NOTICE OF SHORELINE TASK FORCE REGULAR MEETING
CITY OF SOUTH PADRE ISLAND

ITEM
Discussion and action to provide a recommendation to City Council regarding a beach and dune permit at 5820 Gulf Boulevard. (Kornblum)

TO: Mei Ling Valdes, General Land Office
FROM: Emily Kornblum, Coastal Coordinator
DATE: 26 August 2026
RE: Preliminary determination on proposed construction at 5820 Gulf Boulevard

Beachfront Construction Certificate and Dune Protection Permit in the City of South Padre Island
Site Address: 5820 Gulf Blvd, South Padre Island
Legal Description: So Padre Is- Fiesta Isles Lot 6 Blk 191
Lot Applicant: Robert Moya c/o Alfredo Silva Jr.
GLO ID No.: BDSPI-26-0151

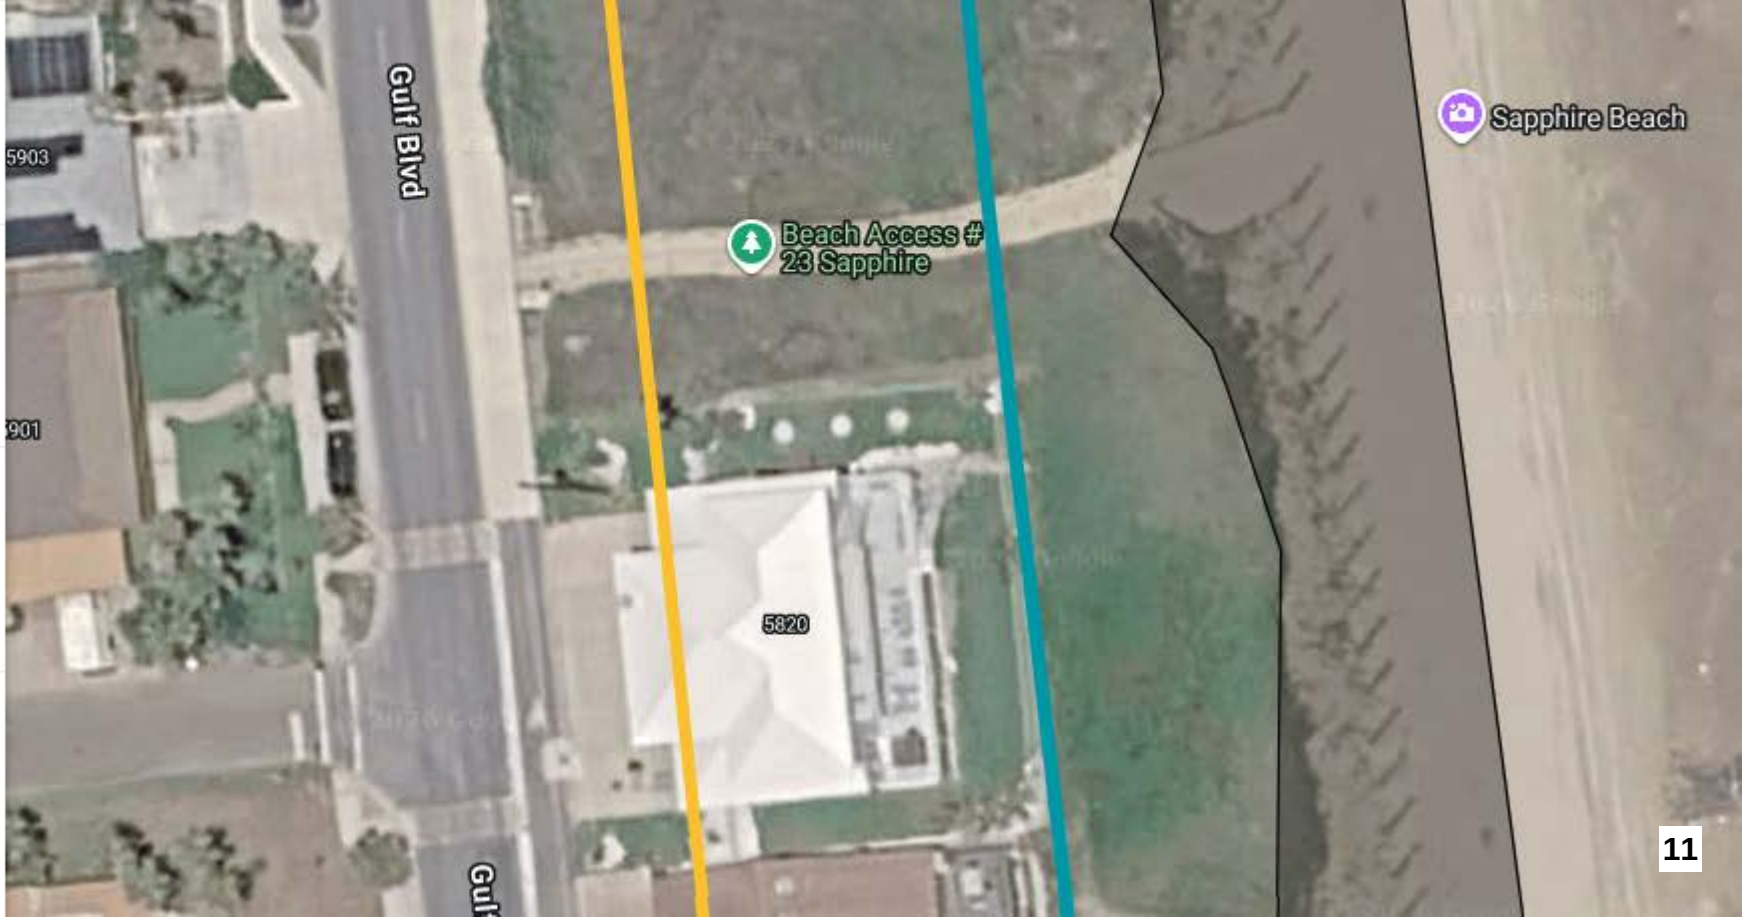
Because the proposed property and walkover are located within 100 feet of a public beach access point (as indicated on page 5 of the application), the project conflicts with the proposed special provisions of the City's *Dune Protection, Beach Renourishment, and Beach Access Plan*. These provisions that have been put forth regulate new access paths and dune walkovers within a 100-foot buffer of any public access location to prevent unnecessary dune fragmentation and promote shared access routes.

COVER PAGE & SITE PLAN

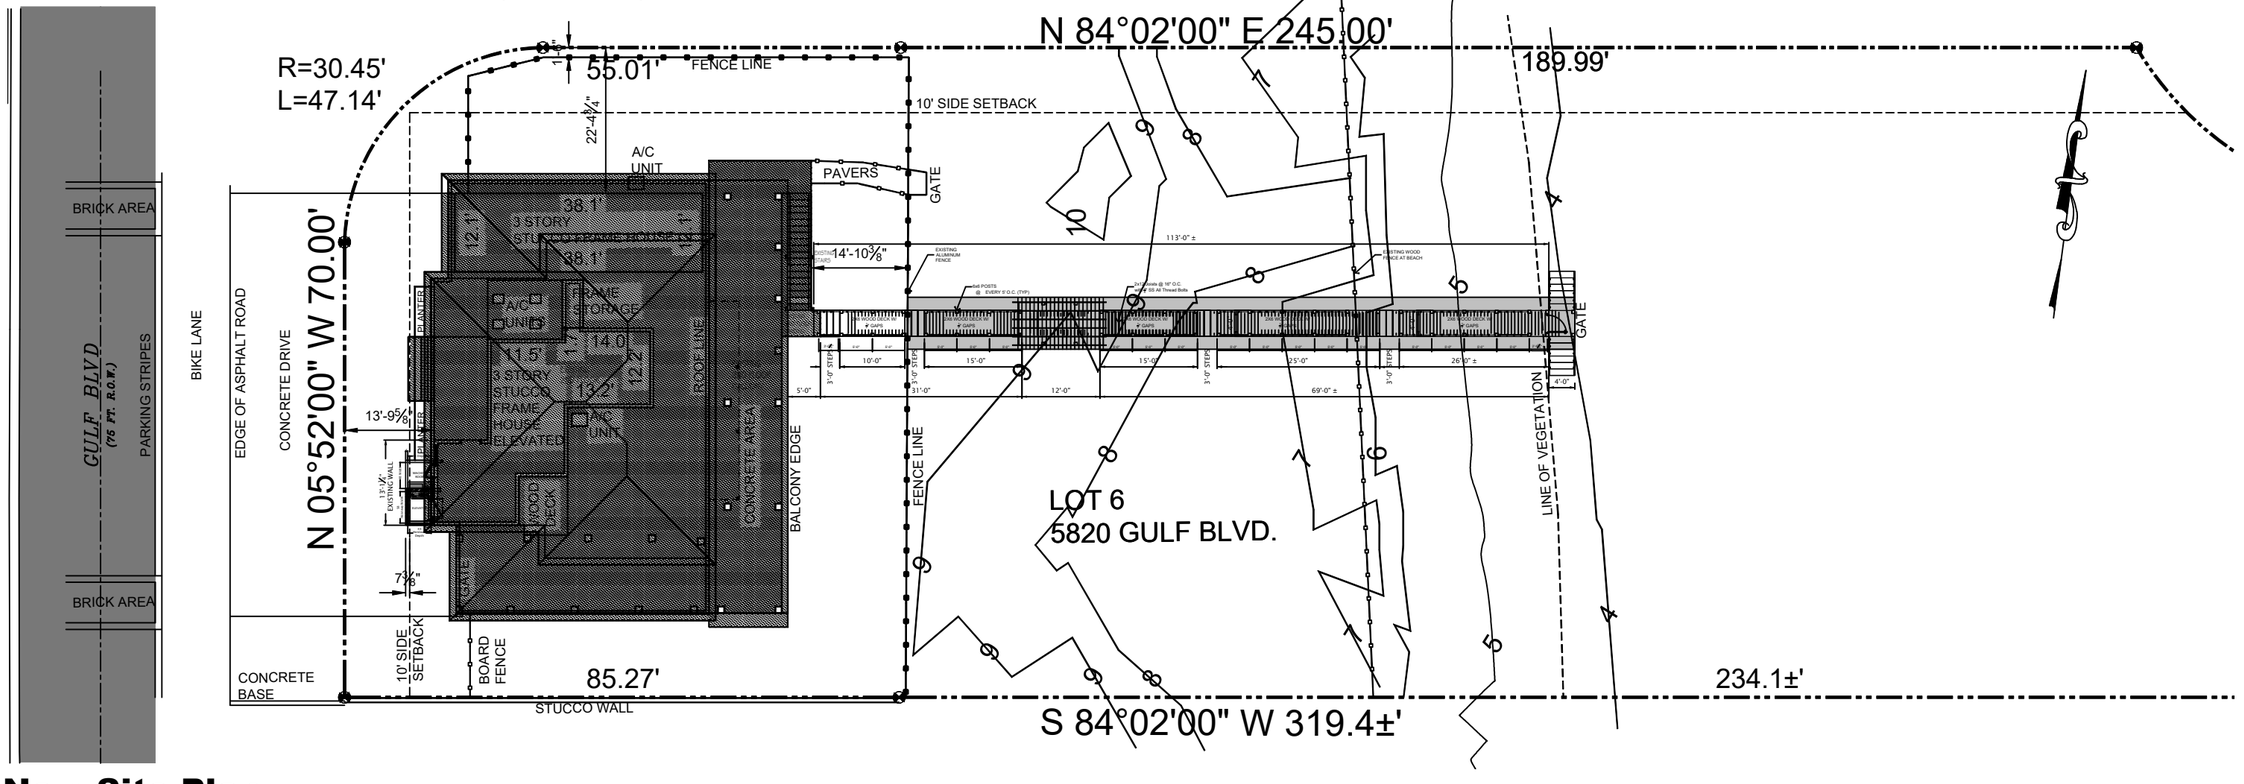
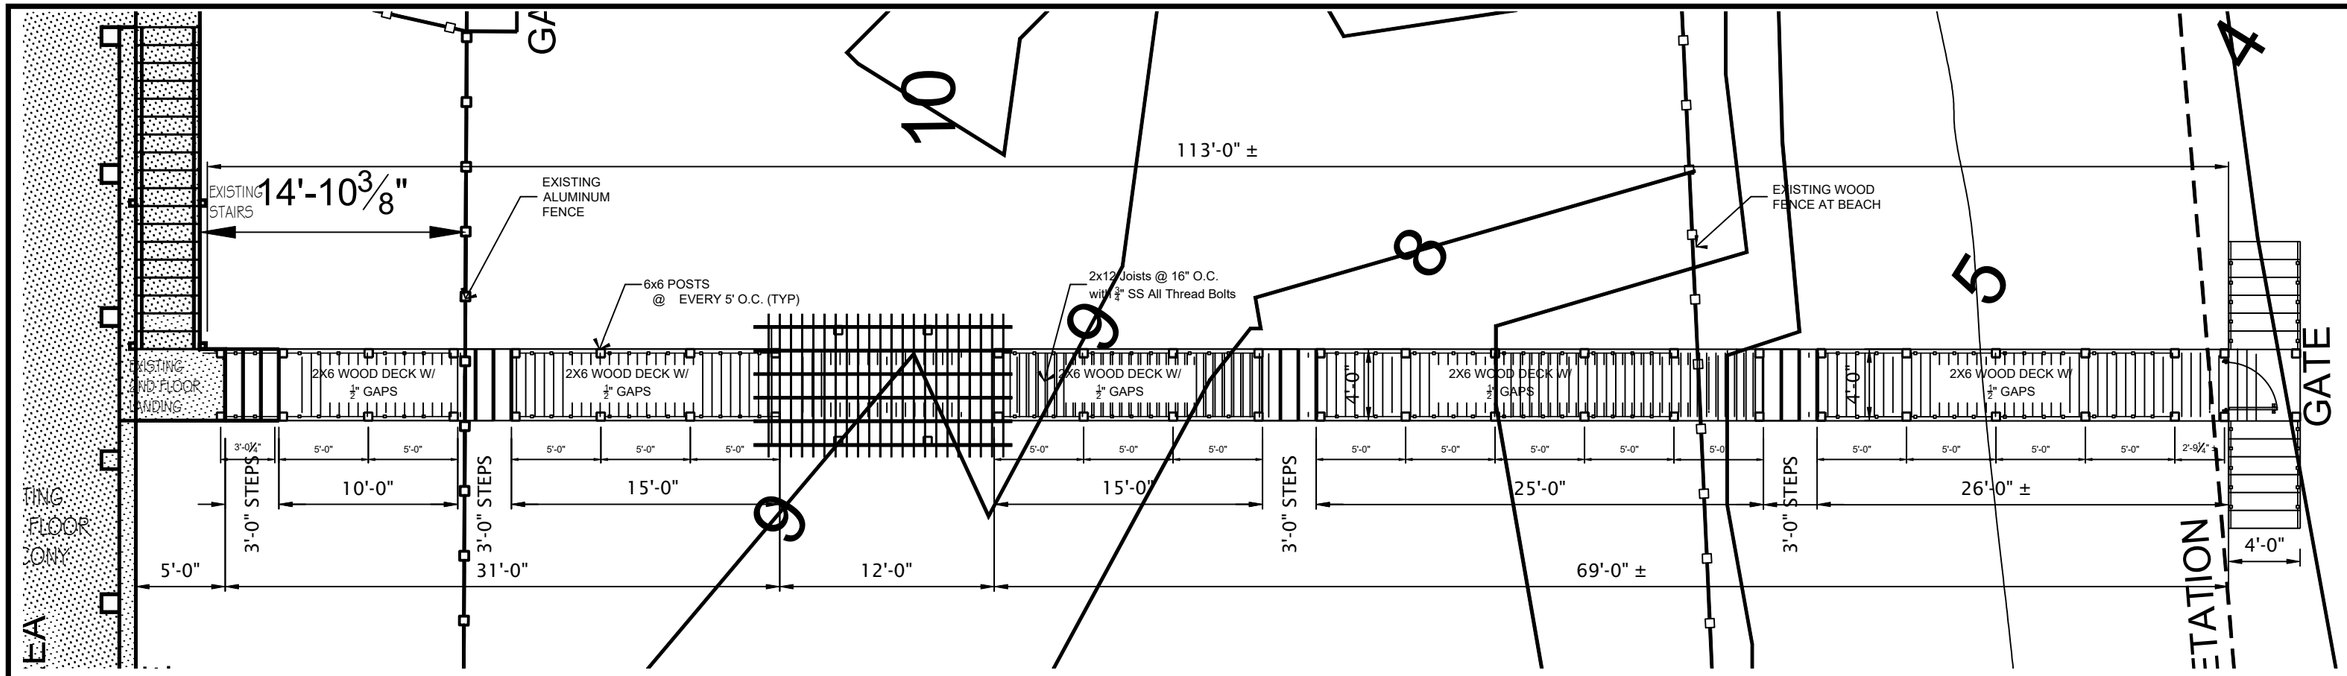
City staff advised the applicant to avoid constructing an entirely separate pathway through the dunes by either using the existing public access or connecting a new path directly into it. Although informed of this recommendation, the applicant chose not to modify the design to integrate with the public access. Consequently, the proposed plan does not comply with the City's Beach Use and Access Plan.

- It appears that the location of the proposed dune walkover may interfere with the City's ongoing dune restoration project using sand fencing. The applicant should coordinate with the City on any necessary modifications to the existing sand fencing.

- The City must ensure the applicant has demonstrated compliance with the avoidance and minimization steps of the mitigation sequence before issuing the permit. [7] It appears that the proposed impacts to dunes and dune vegetation might be avoidable by not constructing the private dune walkover since there is a public beach access pathway on the neighboring property.

FLOOR PLAN & DETAILS

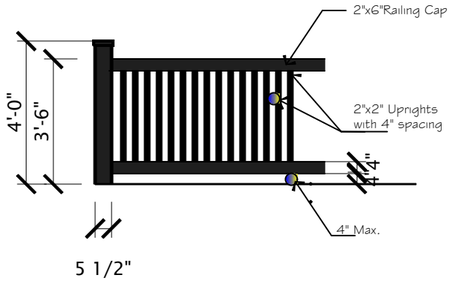
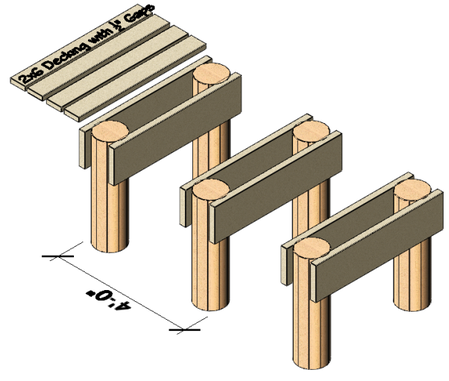
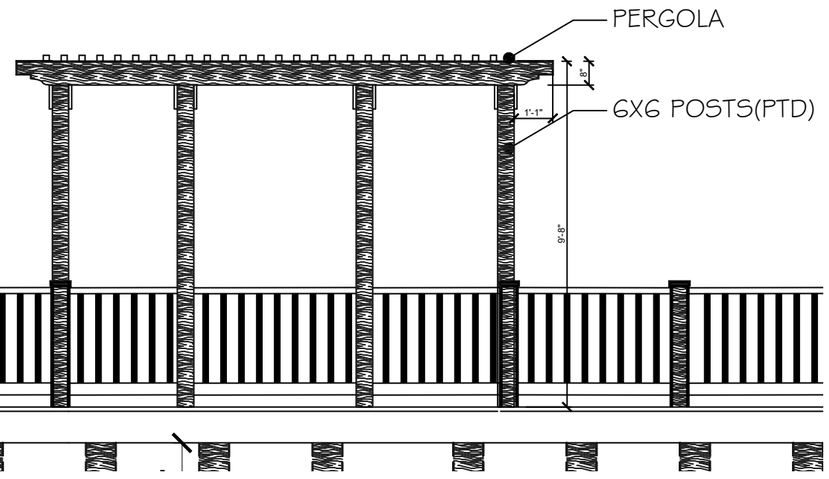
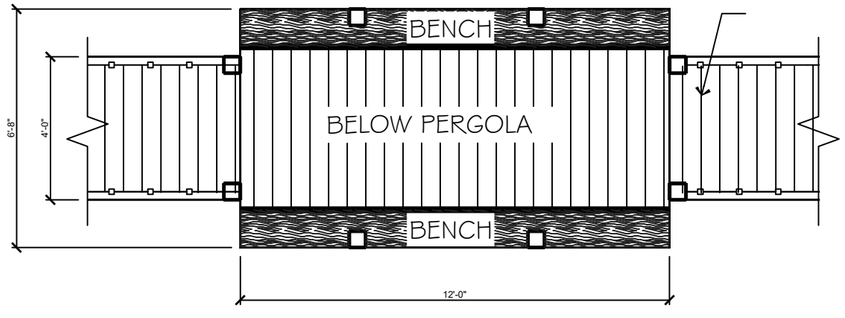
- The applicant proposes to construct a 4-foot-wide dune walkover with a 12-foot by 8-foot pergola structure, which does not comply with the width requirements for dune walkovers and similar structures in the Texas Administrative Code (TAC). 31 TAC 15.6(i)(1)(A) requires the width of a dune walkover or similar structure to be limited to 4 feet wide.[1] An increased width may be permitted for public access walkovers, shared walkovers for three or more residences, or wheelchair or golf-cart use with approval from the local government.[2]
    - The pergola does not meet the above exceptions for an increased width.
    - Before the City issues a permit, the applicant must submit revised plans to the City demonstrating that the dune walkover and pergola structure will be limited to 4 feet wide.

- The use of concrete to stabilize dune walkover pilings is prohibited.[6]
